DOCKETED	
Docket Number:	23-OPT-01
Project Title:	Fountain Wind Project
TN #:	260101
Document Title:	County of Shasta Comments on Wildfire, Economics, and Various Project Environmental Issues
Description:	County of Shasta Comments on Wildfire, Economics, and Various Project Environmental Issues
Filer:	Kari Cameron
Organization:	County of Shasta
Submitter Role:	Public Agency
Submission Date:	11/15/2024 3:57:27 PM
Docketed Date:	11/15/2024

Office of the County Counsel
County of Shasta

Re: Docket 23-OPT-01: County of Shasta AB 205 Review and Comments on Fountain Wind Project (Wildfire Impacts and Safety, Economic Benefits, Alternatives Analysis, Visual Simulations, Aquatic Survey, & Rare Plant Survey and Native Vegetation Community)

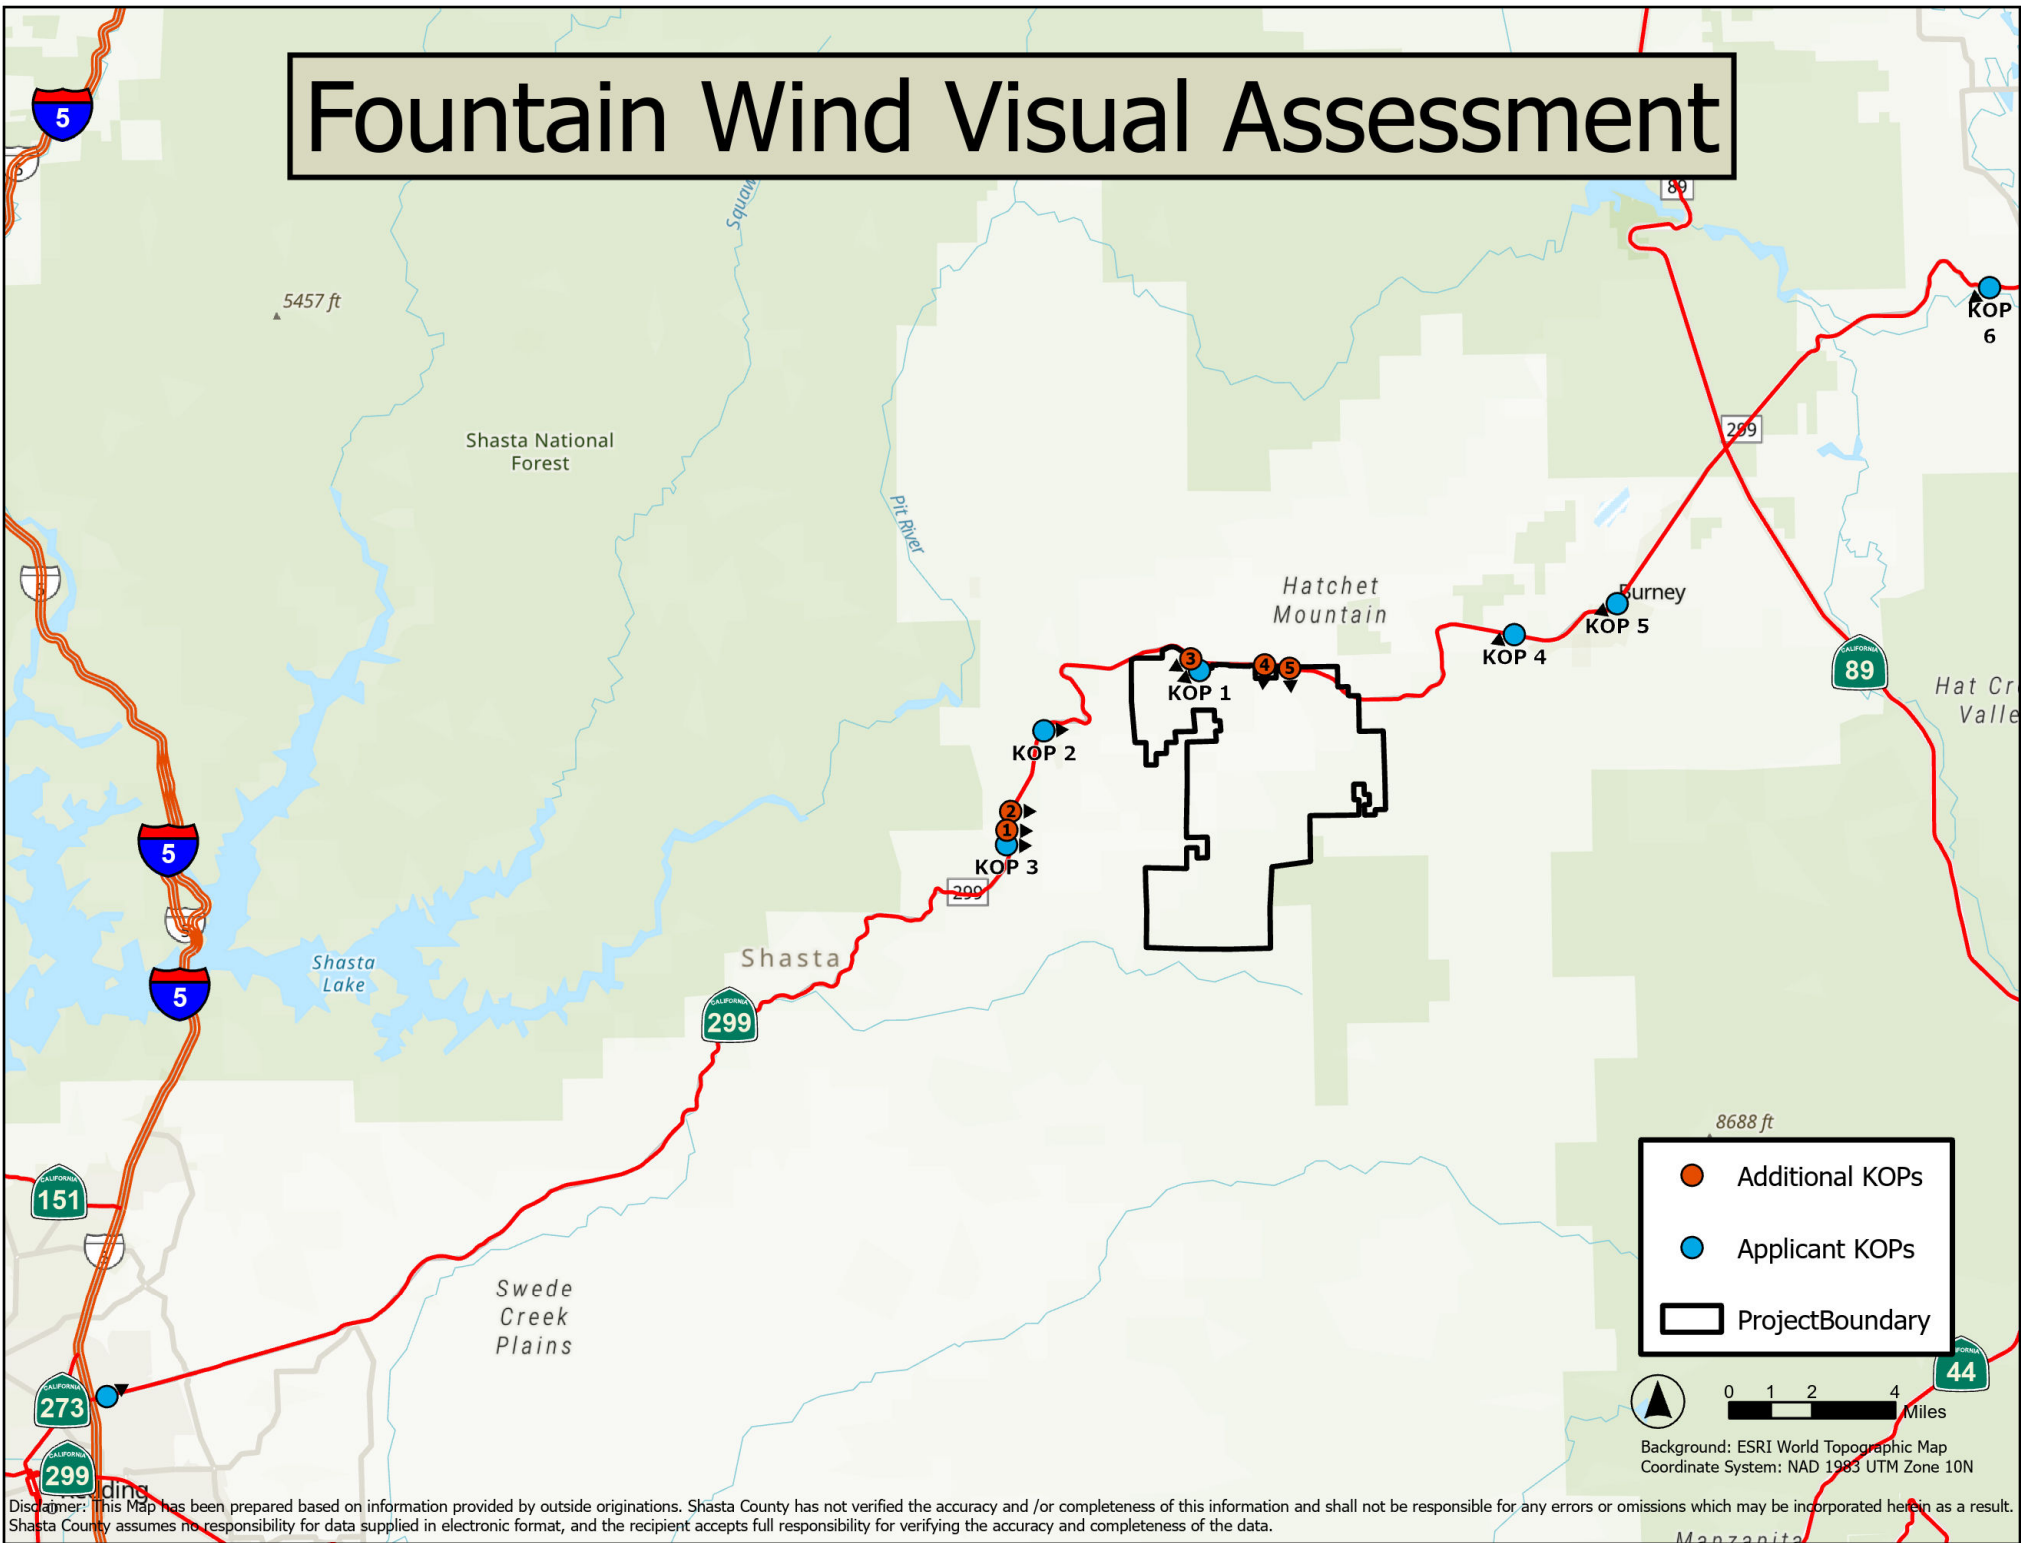
KOP 2, 3a, 3b, 5a, and 5b appear too small in size and of low digital resolution to see key details of the turbines. A more accurate and adjusted view of KOP 3a would capture a larger landscape frame, including landscape elements reflected on the left side of the panoramic view. Additionally, the KOP 3a, KOP 3b, and KOP 5b simulations are based on images taken a distance from the State Route 299 mainline. These KOPs depict far away views resulting in project and landscape elements appearing too small and lacking realistic detail presenting the reviewer with an unrealistic and distorted visual perspective of the project and its visual impacts at these locations.

Photosimulations submitted in Docket Number: 23-OPT-01, TN# 251199, omit a dedicated KOP that evaluates the impacts associated with the proposed O&M Building. Additionally, and as noted in the VIA Addendum, proposed meteorological towers constructed onsite would be up to 394 feet high and painted in aviation-safe orange and white. Although no meteorological towers appear in the photosimulations, a new, potentially focused simulation should be prepared from State Route 299 to illustrate at least one meteorological tower in relation to the wind turbines. Absent a specific photosimulation of the O&M building and at least one meteorological tower, the VIA Addendum should expressly state the rationale for not modeling these important project elements.

Fountain Wind Visual Impacts Figure (Applicant KOPs/Additional KOPs)

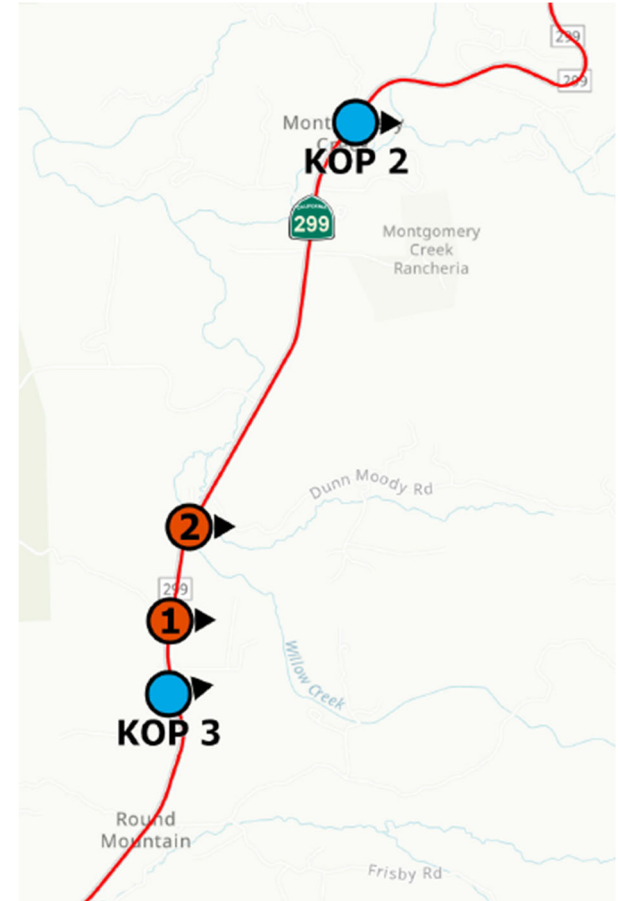
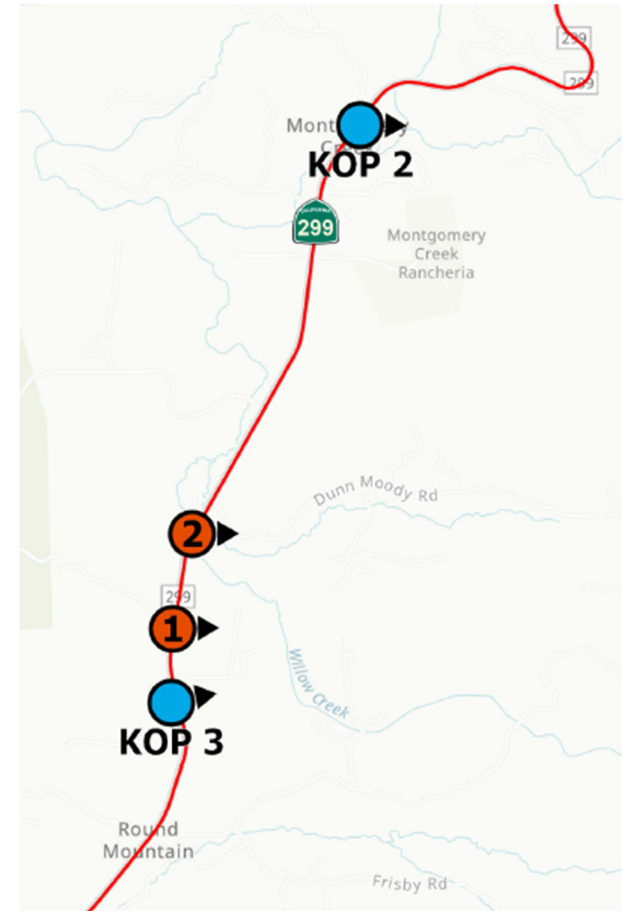
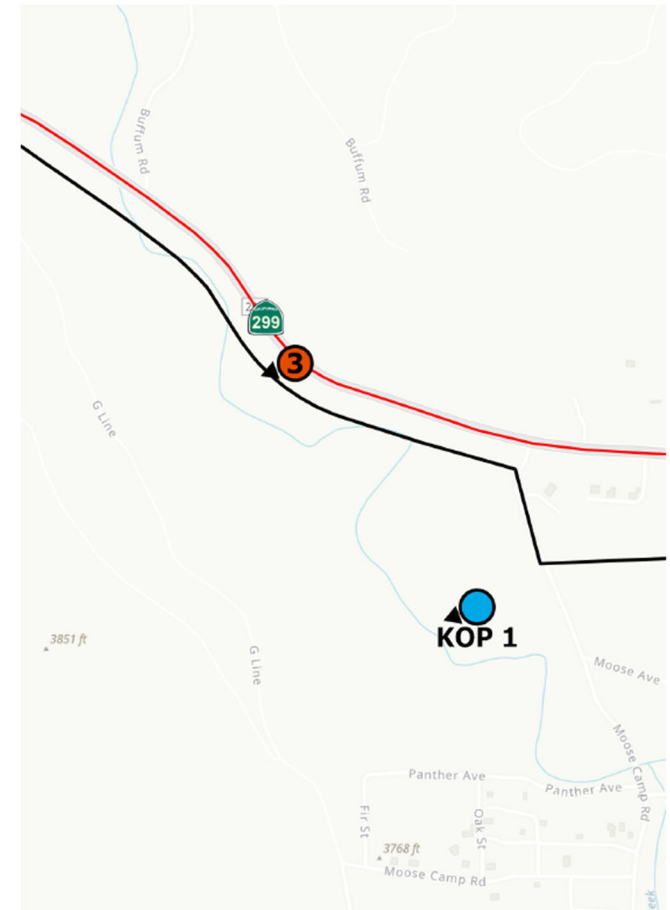
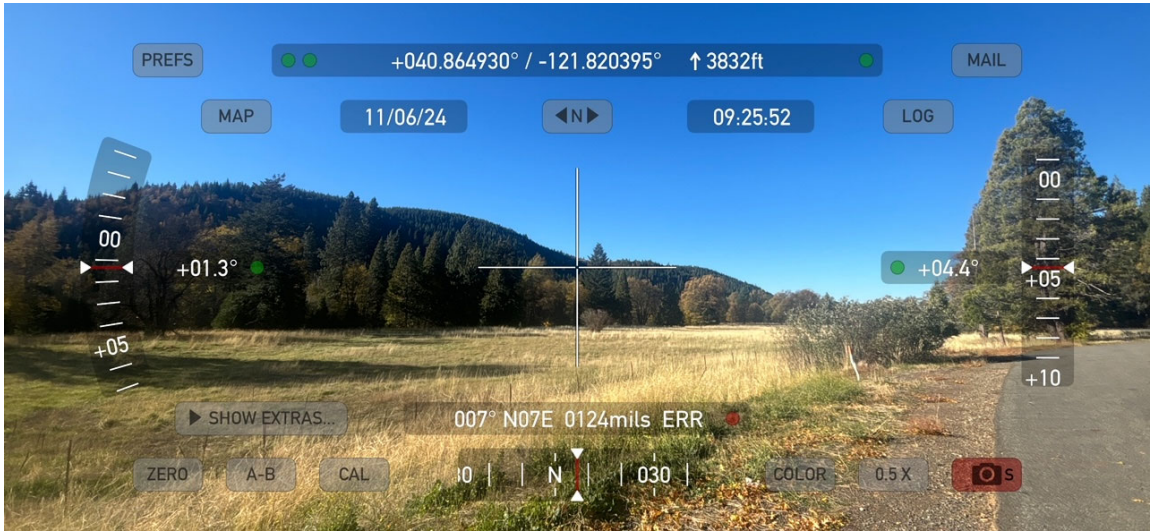
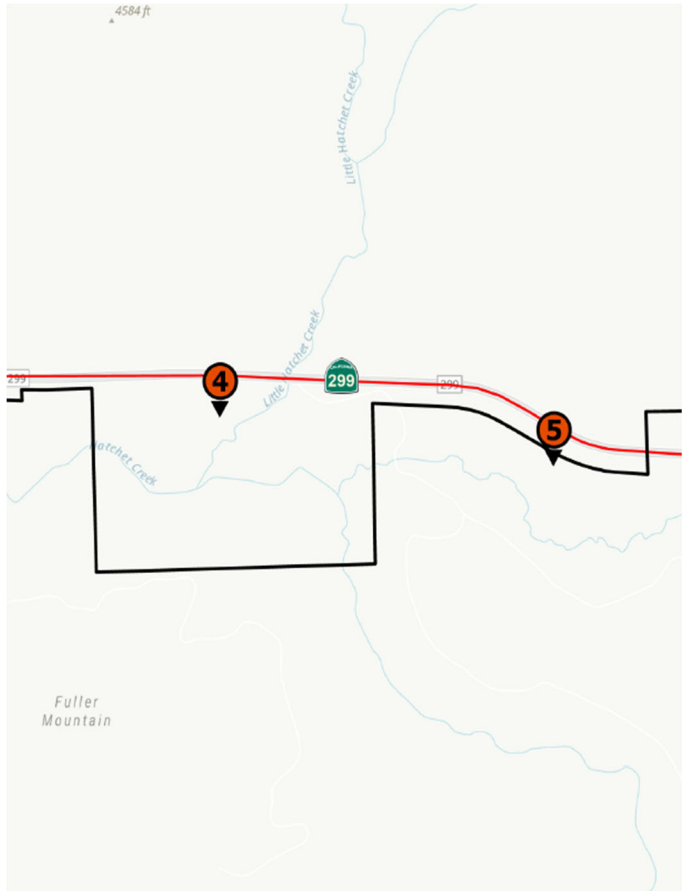
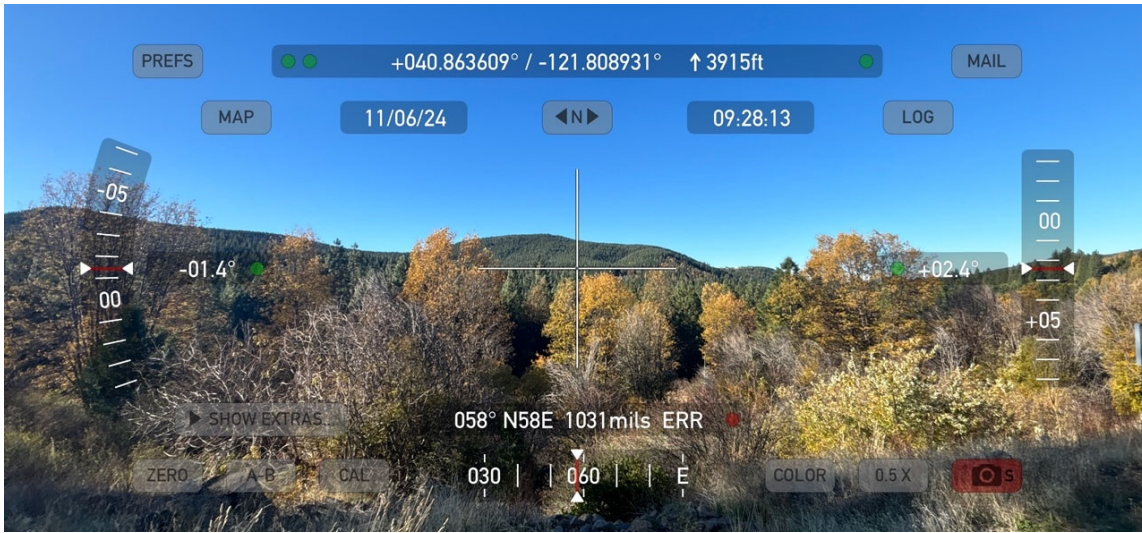
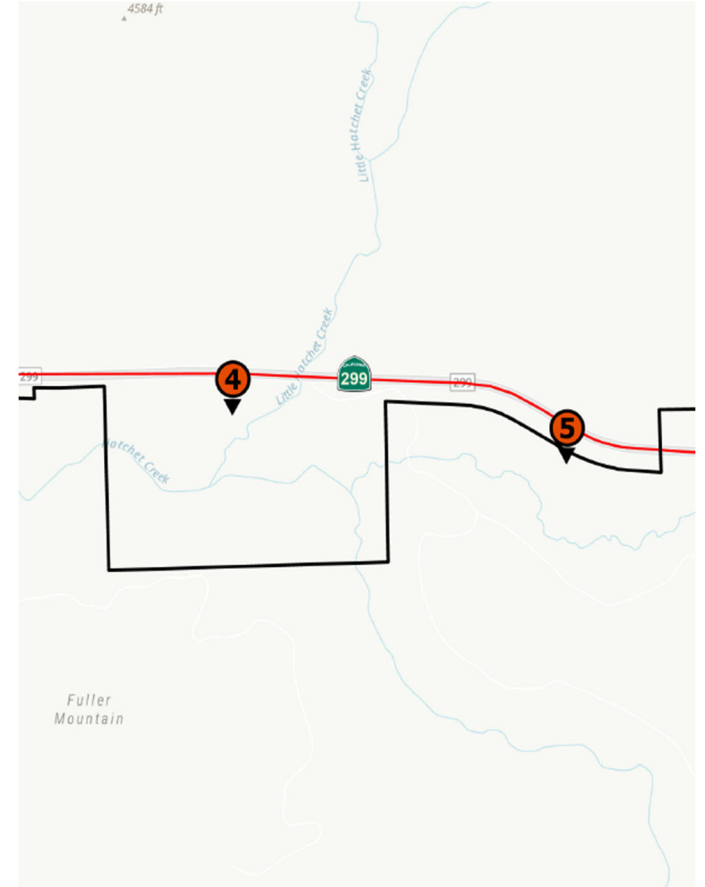
Photosimulations developed for specified viewpoints can only depict the views from those exact locations, and thus, they omit potential views of the project from all other locations within the viewshed. The current revised KOP views represent only a small part of the total area from which the project would be visible. We believe these views are limited in scope, limiting the CEC’s ability to render an informed decision based on the range of anticipated project impacts (see Docket Number: 23-OPT-01, TN# 250566). In collaboration with County staff, the following KOP locations within the viewshed area should be considered by the CEC:
